## Product Change Notice (PCN)

PCN Number: **PCN-0451204R-01**

Product(s) Affected: **PJ-057AH**

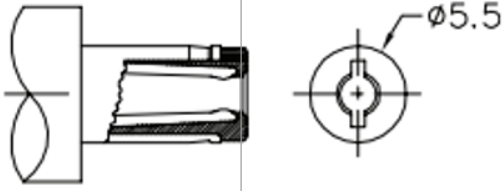
Description of Change: **Minor Housing and footprint differences. Material Change on the housing and terminals. See image Below**

| PREVIOUS CUI DEVICE'S DETAIL / IMAGE |              |         | NEW CUI DEVICE'S DETAIL / IMAGE |                 |               |
|                                      | MATERIAL     | PLATING | DESCRIPTION                     | MATERIAL        | PLATING/COLOR |
| center pin                           | copper       | nickel  | center pin                      | brass           | nickel        |
| terminal 1                           | brass        | silver  | terminal 1                      | brass t=0.40    | silver        |
| terminal 2                           | copper alloy | silver  | terminal 2                      | bronze t=0.30   | silver        |
| terminal 3                           | brass        | silver  | terminal 3                      | brass t=0.40    | silver        |
| plastic                              | PBT          |         | cover                           | PA10T (UL94V-0) | black         |
|                                      |              |         | housing                         | PA10T (UL94V-0) | black         |

**MATING PLUG**  
Jack Insertion Depth: 9.15 mm

**MATING PLUG**  
Jack Insertion Depth: 9.45 mm
